ECE/TRANS/WP.29/GRRF/2007/21/Rev.1
4 July 2008

Regulation No. 106 (Pneumatic tyres for agricultural vehicles)

Proposal for draft amendments to Regulation No. 106

Submitted by the expert from the European Tyre and Rim Technical Organisation^{*/}

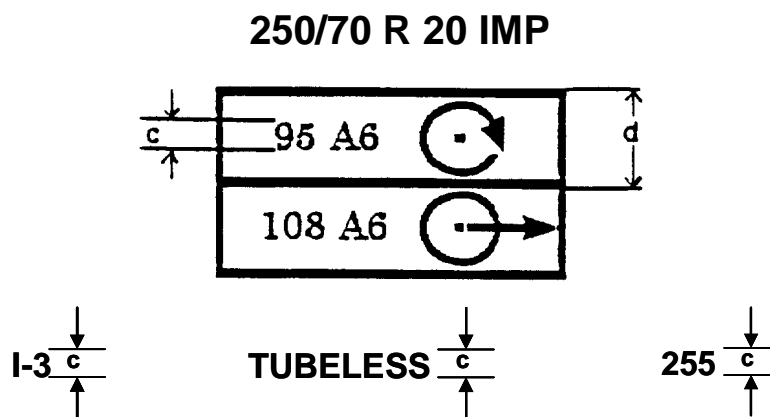
Insert a new paragraph 3.1.8.2., to read:

"3.1.8.2. The inscription 'I-3' for implement tyres with traction tread as identified in Annex 5, tables 5 and 6."
